Addendum Number 3

Lake Peachtree Spillway Replacement Project

August 4, 2017

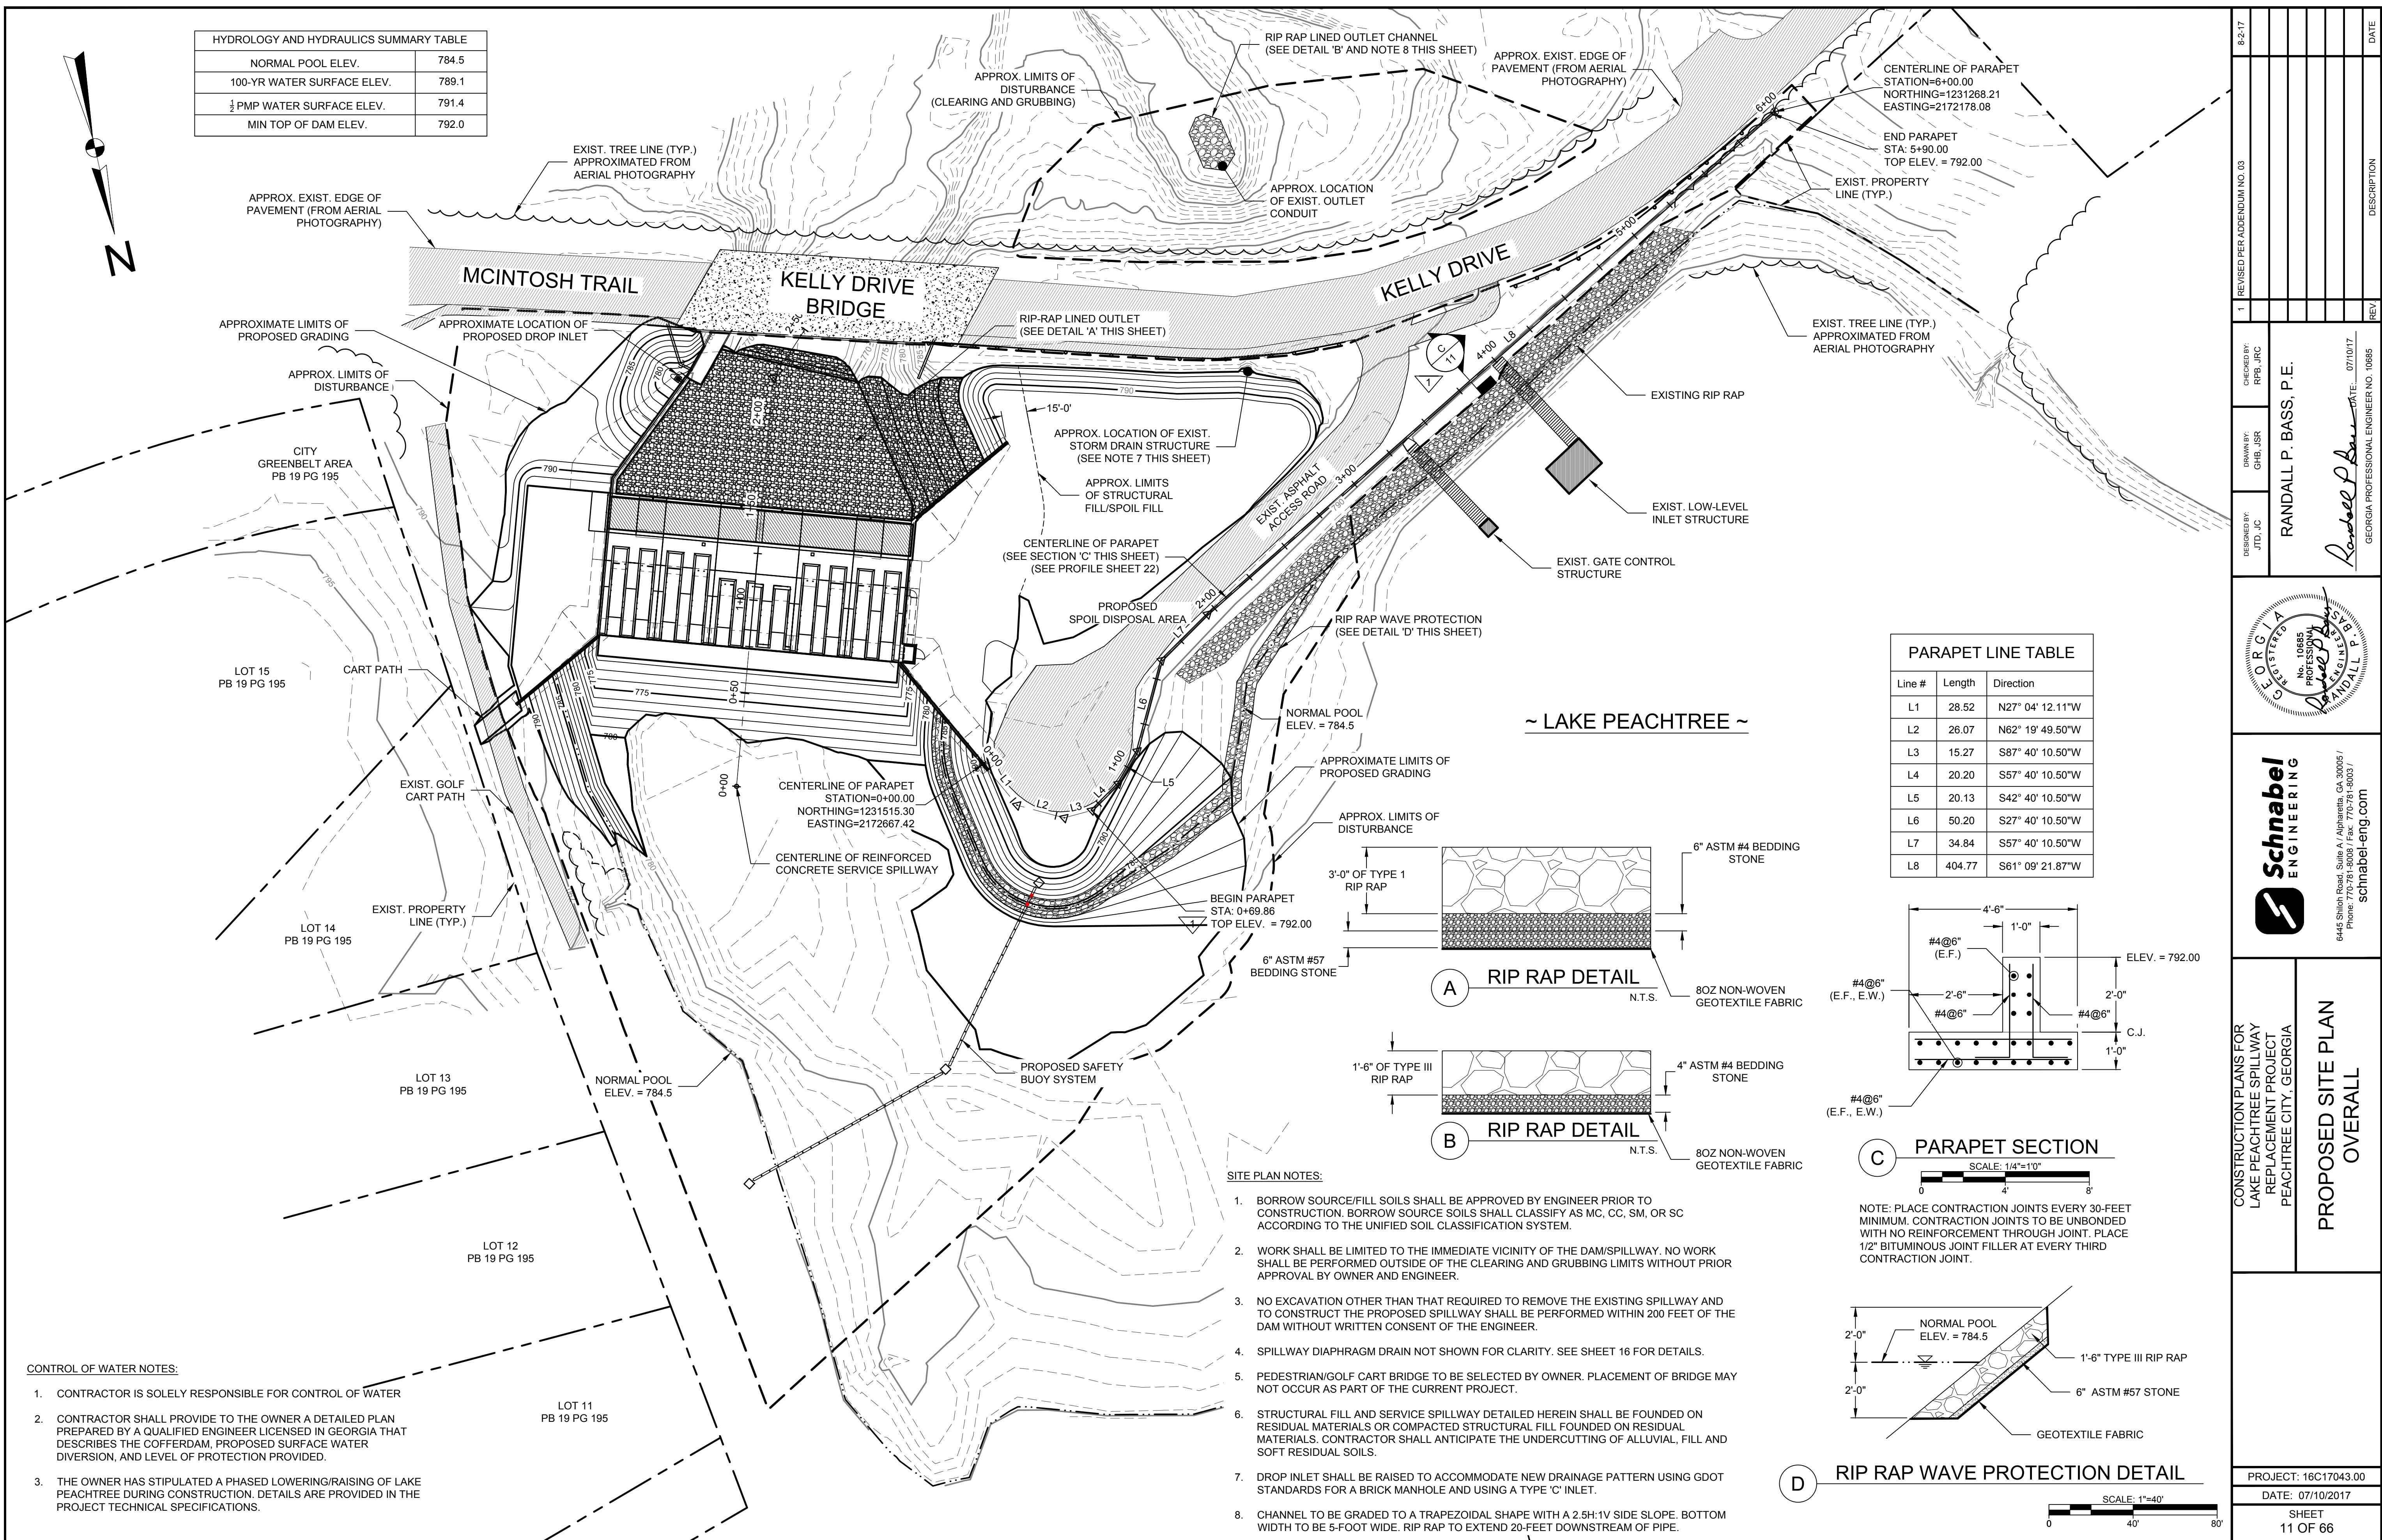
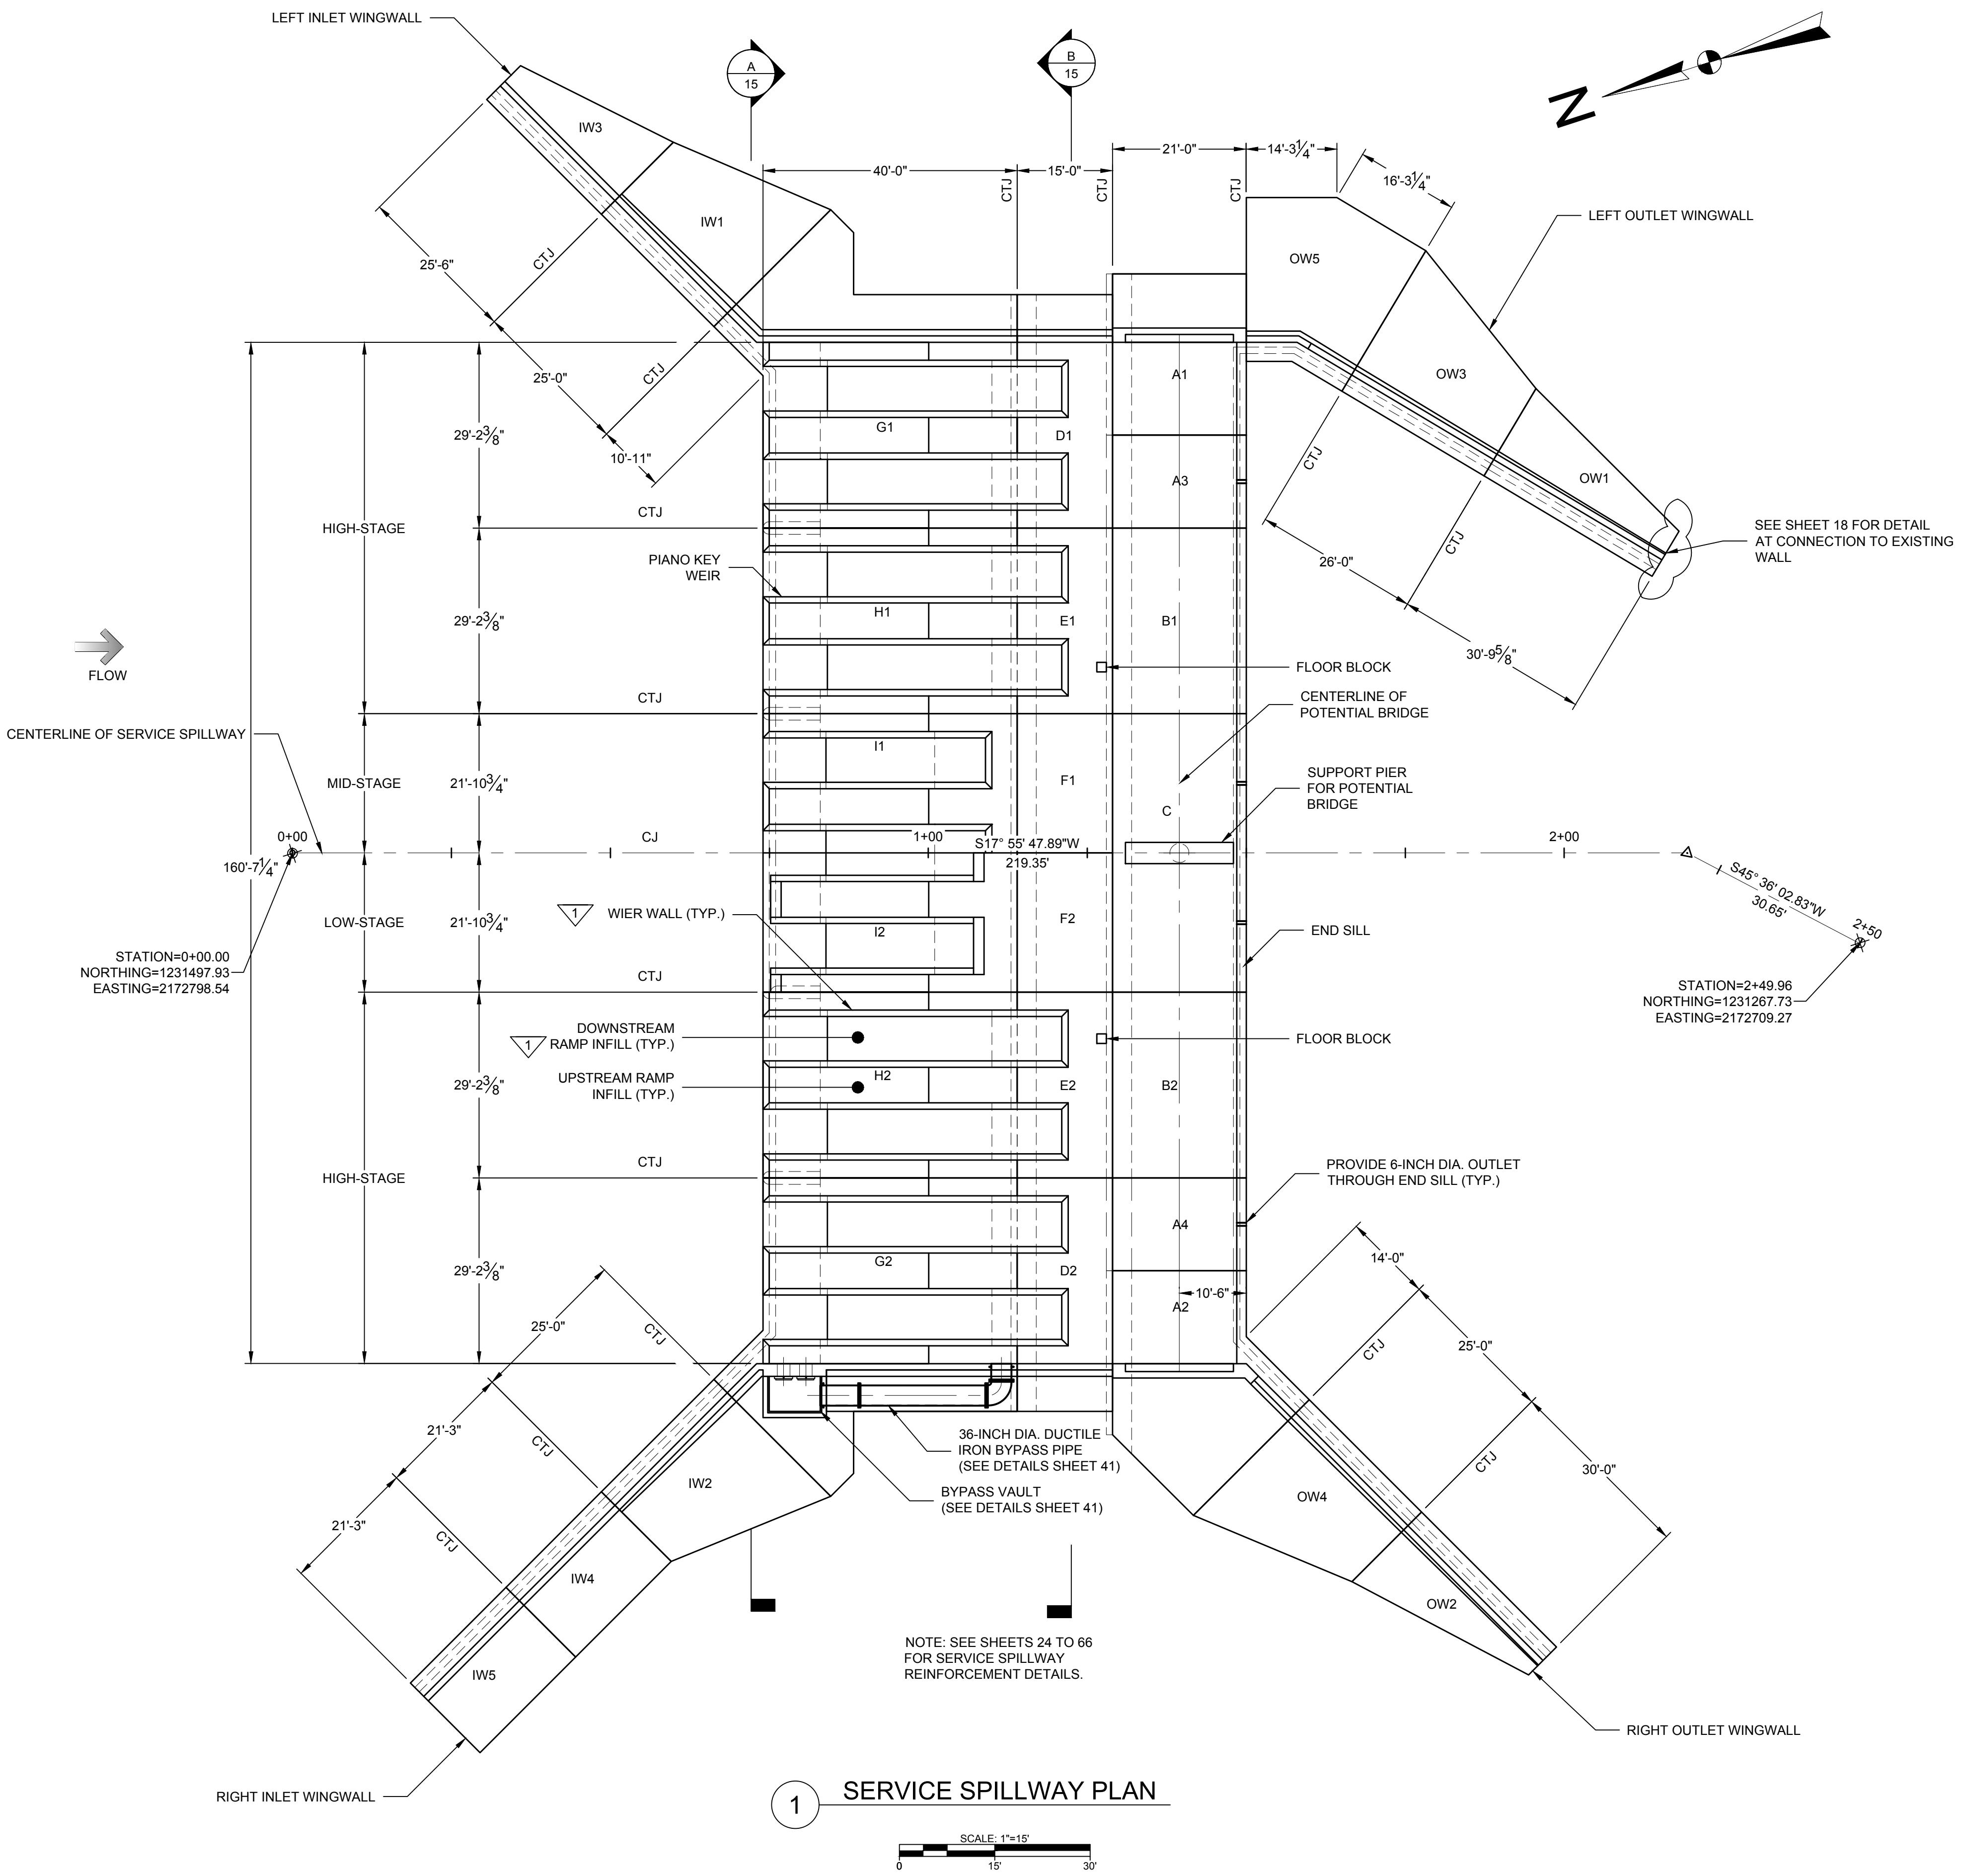
Note: Additional temperature and shrinkage reinforcing steel was added in the ramp/infill sections of the piano key weirs. Sheets with material changes were noted as Revised per Addendum No. 3. Sheets that were inadvertently affected by the changes are included, but do not contain revision clouds/call-outs. The additional reinforcing typically includes the addition of #5@12" spacing, #7@12" spacing, and #4@24" spacing depending on the specific locations of reinforcing.
